AGENDA
PLANNING COMMISSION
116 WEST NEEDLES
BIXBY, OKLAHOMA
May 19, 2014 **6:00 PM**

**MINUTES
PLANNING COMMISSION
116 WEST NEEDLES
BIXBY, OKLAHOMA
April 21, 2014 6:00 PM**

To: Erik Enyart, City Planner
From: Jared Cottle, City Engineer *JWC*
CC: Bea Aamodt, Public Works Director
File
Date: 05/12/14
Re: Bricktown Square, PUD 31
Major Amendment #1 Review

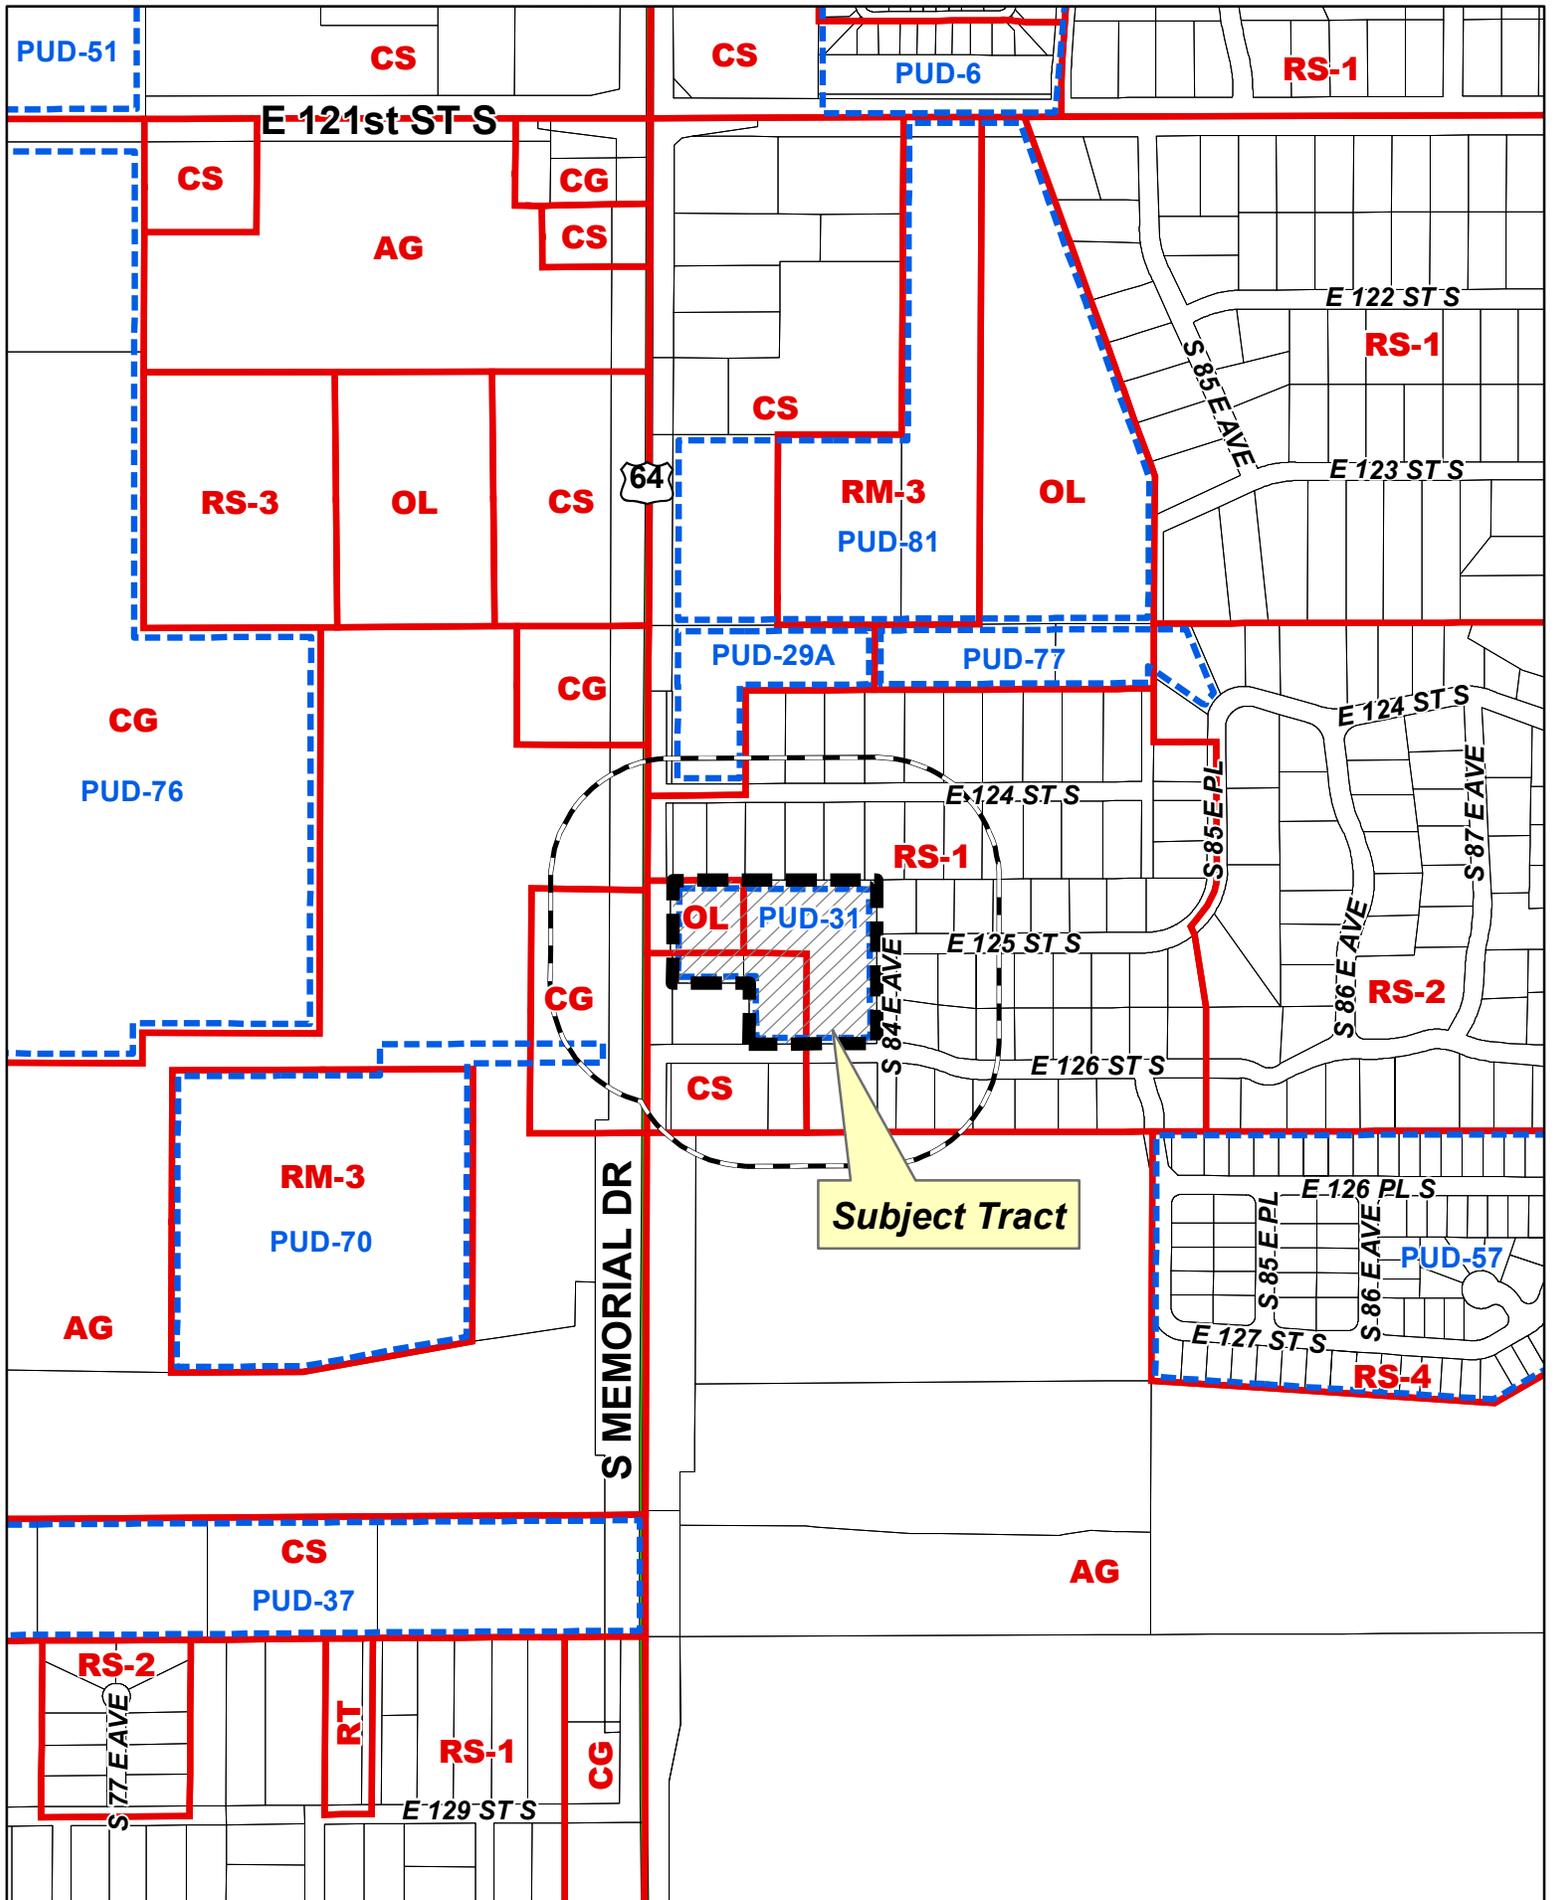
1. Reserve Areas should be utilized to encapsulate the overland drainage systems (grass and swales and concrete swales) with overland drainage rights and maintenance responsibilities allocated to the Property Owners association, or individual lot owners.
2. Previous projects have provided sufficient storm sewer capacity to provide off-site drainage. However, fee-in-lieu charges for discharge to Fry Creek will still apply.
